TOWN OF HORIZON CITY
Planning and Zoning Commission Staff Report

Case No.: SDF26-0001 Verdancia Unit 3 Final

Application Type: Final Subdivision Plat Application
P&Z Hearing Date: July 20, 2026
Staff Contact: David Ruiz, Planner
915-852-1046, Ext. 404; druiz@horizoncity.org

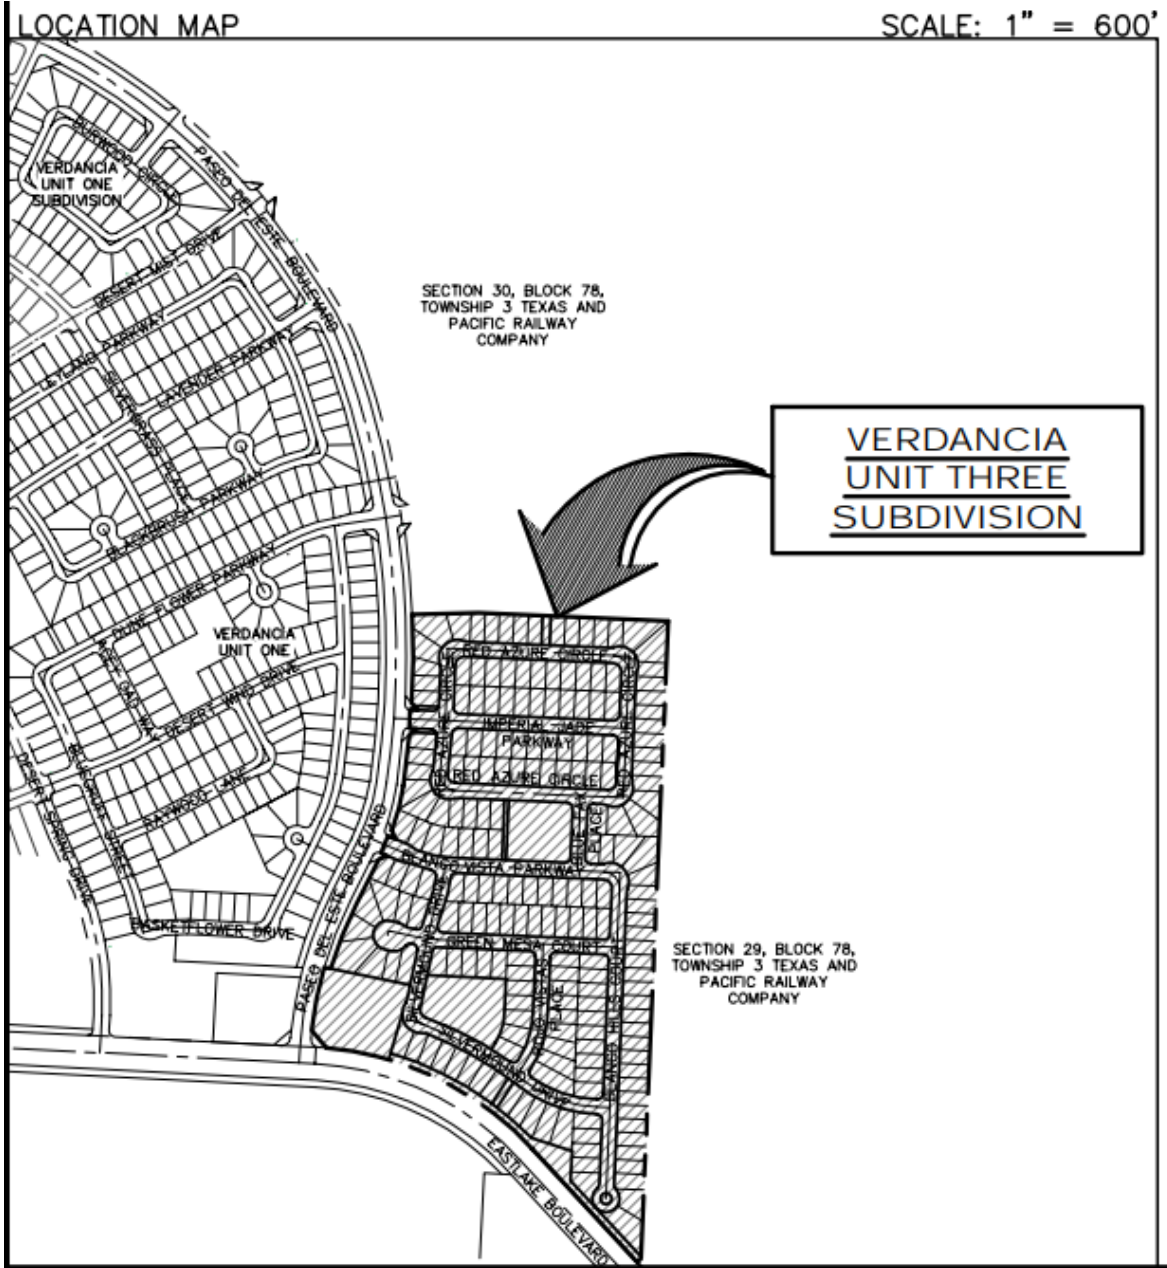
1. What is the proposed use on Lot 1, Block 1, was it supposed to be a lot?

2. What is the proposed use on Lot 1, Block 4, was it supposed to be a lot?

3. Missing property boundaries between Lot 76-77, Block 1

NOTES:
1. CUL-DE-SAC ISLAND LANDSCAPING TO BE MAINTAINED BY HOA.
TYPICAL CUL-DE-SAC PARKING LAYOUT
SCALE: N.T.S.

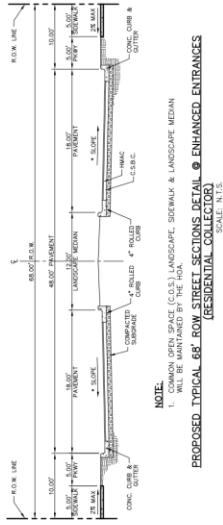
3. Modification to use 53.50-foot radius Cul-de-Sac streets with interior landscape/parking islands and outside travel lane roadway width of 24-feet. The proposed cul-de-sac and landscape/parking islands will enhance the neighborhood character, reduce the impervious surface, aid to eliminate typical cul-de-sac "stack" parking and maintain adequate room for emergency vehicle turning movement. Landscape areas will be maintained by the HOA.

NOTE:
1. COMMON OPEN SPACE (C.O.S.) LANDSCAPE, SIDEWALK & LANDSCAPE MEDIAN WILL BE MAINTAINED BY THE HOA.
2. MEASURING AT TRAIL WITHIN R.O.W. & COMMON OPEN SPACE.
PROPOSED TYPICAL 68' ROW STREET WITH C.O.S. TRAIL SECTIONS DETAIL @ ENHANCED ENTRANCES (RESIDENTIAL COLLECTOR)
SCALE: N.T.S.

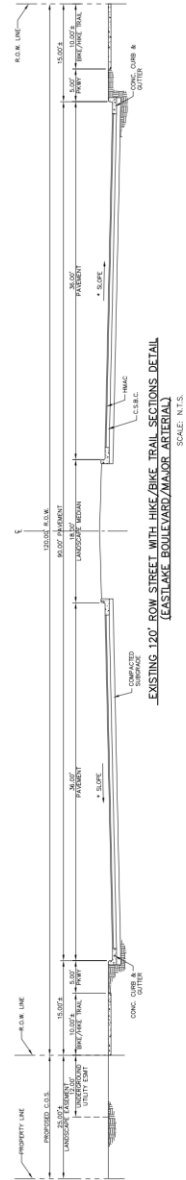
1. Modification to use a 68-ft residential collector at enhanced neighborhood entrances. The 68-foot street right-of-way will consist of two 5-ft parkways, two 5-ft wide concrete sidewalks, two 18-ft wide pavement structures and a 12-ft raised landscape median with curbs & gutter. Landscape areas will be maintained by the HOA.

2. Modification to use a 68-ft street right-of-way with meandering trails at all local residential sub-collector streets at enhanced neighborhood entrances abutting common open space lots. The 68-ft street right-of-way will consist of two 5-ft parkways, 36-ft wide pavement structure with curb & gutter, a 12-ft raised landscape median and two 8-ft wide meandering trails. The 8-ft trails will meander within the street right-of-way parkway area and the adjacent 15-ft common open space landscape lot. This will provide a visually appealing and safe walking trail along this corridor. Landscape areas will be maintained by the HOA.
